NABCO ENTRANCES TECHNICAL BULLETIN

Swinger Arm Stop – Outswing Units

Bulletin Number: 39

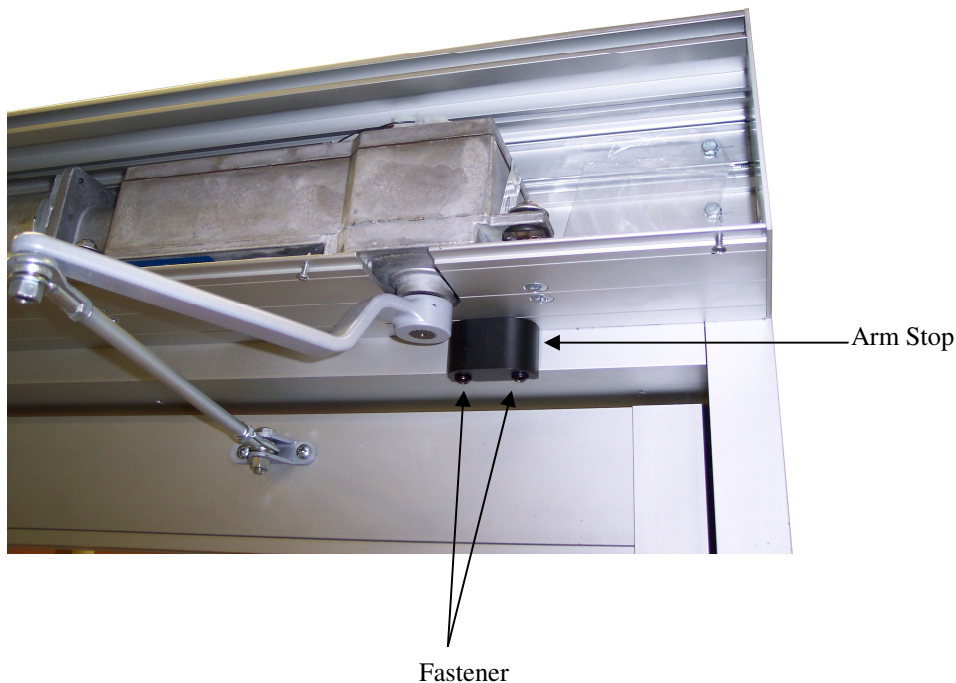
The arm stop used on GT710 and Sideload units was redesigned. This design change required a new longer fastener. The fastener needed for the new arm stop is a ¼-20 x 1 ½” Long Phillips Pan Head Type F Self Threading Fastener (24-4941-21). If you have received the arm stop and need the longer fasteners, please contact customer service. The fasteners will be shipped regular UPS at no charge or can be shipped with your next order. Our records show that the longer fasteners are needed on orders shipped with the new arm stop from 5/16/07 to 7/11/07.
